CERTIFICATE OF APPROPRIATENESS

Property: 2116 Chilton Road, Lot 24, Block 52, River Oaks Subdivision. The property includes a historic 5,056 square foot, two-story brick single-family residence situated on a 12,000 square foot interior lot.

Proposal: Alteration –Replace all non-original single-hung wood windows and non-original doors on the front and side elevations of the house.

Recommendation: **Partial Approval: Approval to replace the front door; Denial for window replacement on the original house**

SOUTH ELEVATION – FRONT FACING CHILTON ROAD

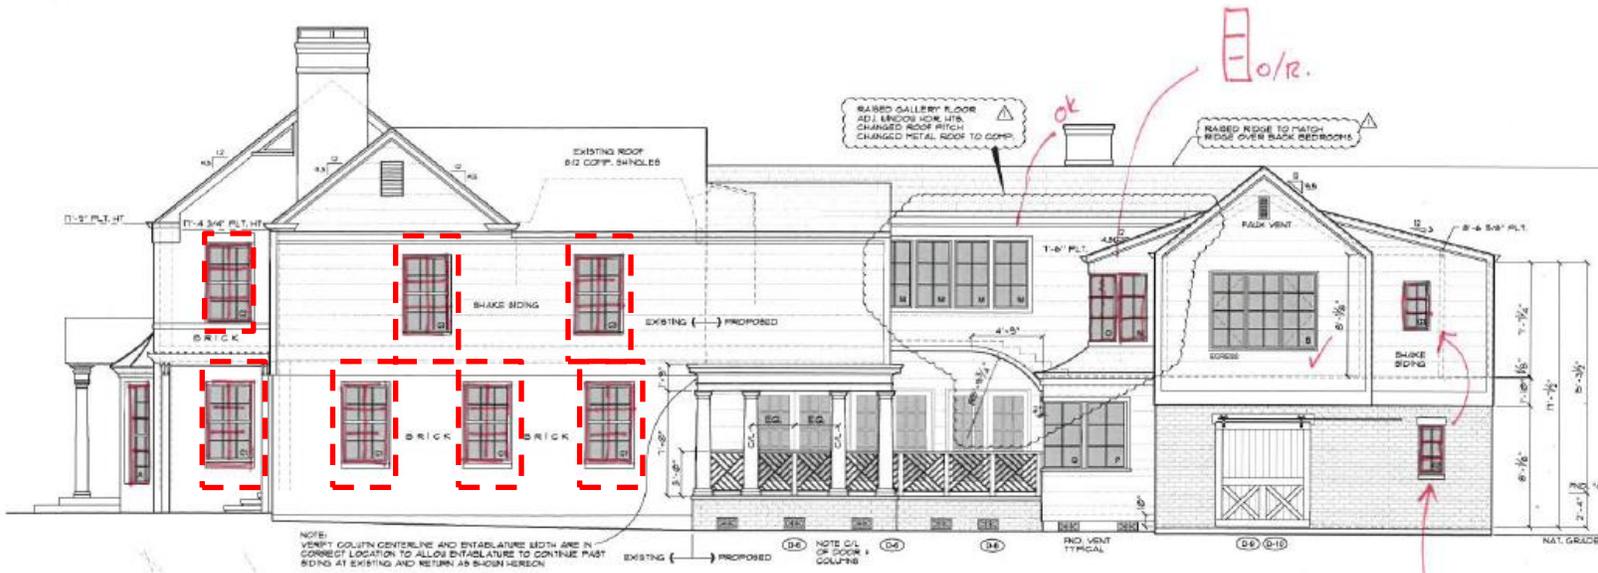
<i>The proposed more modern light configuration of the proposed windows is not compatible with what is found in the Colonial Revival architecture style. Lighting configuration that is present is compatible and should remain.</i> | |

<i>Changing of the window will give the historic house a more modern appearance. Style and lighting configuration that is present should remain.</i> | |

<i>Existing windows are wood and applicant is proposing vinyl windows.</i> | |
